ADDENDUM #9

Snowden Admin Building Mechanical Upgrades Project No. ANC-C-23-0001

Date: December 8, 2022

D.W.V. METRALOOP NO HUB CONNECTION ±4" MOVEMENT

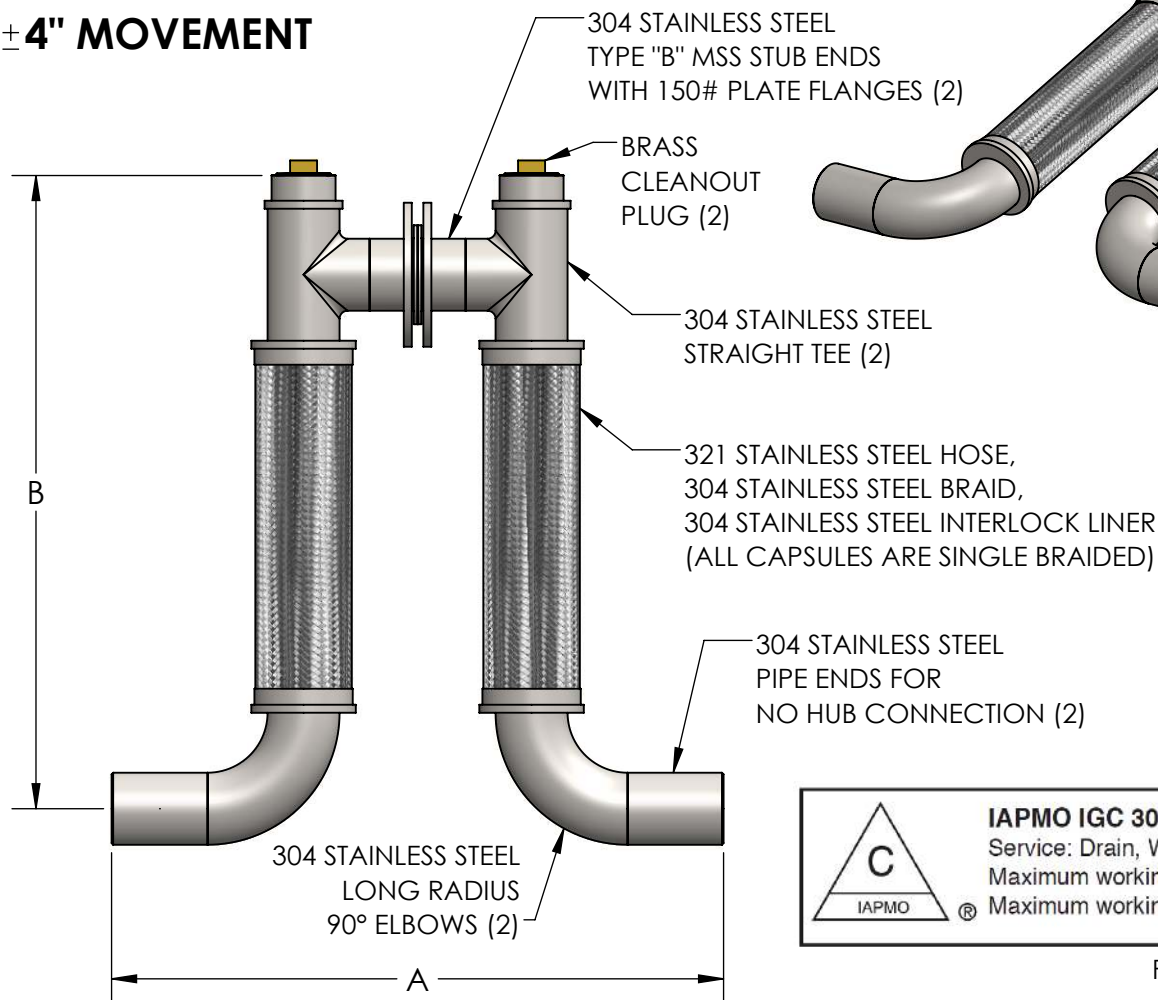
- Note 6 on Drawing M201 states to provide seismic loops at the building joint between grids F and G. Metraloops or other manufactured "V" loops are typically used for heating or other non-gravity piping. There appears to be several locations where waste and vent piping to the new floor drains will cross through the building joint, New piping from Men's Restroom 128 to the new FD-2 drain in the 2nd floor Fan Room and new Piping from Men's Restroom 209 to the new FD-2 drains near AHU-2 in the 3rd floor Fan Room. The "V" loops will not work in a gravity waste line. What is acceptable to be used for waste and vent lines at the building seismic joint.

For DWV piping crossing building joints, acceptable loops for DWV piping include:
Metraflex DWV Metraloop with no hub connection (+/-4" movement) or equal.

NOTE: D.W.V. METRALOOPS INSTALLED IN ANY ORIENTATION OTHER THAN HANGING DOWN MUST HAVE THE 180° RETURN SUPPORTED. (SEE INSTALLATION INSTRUCTIONS.)
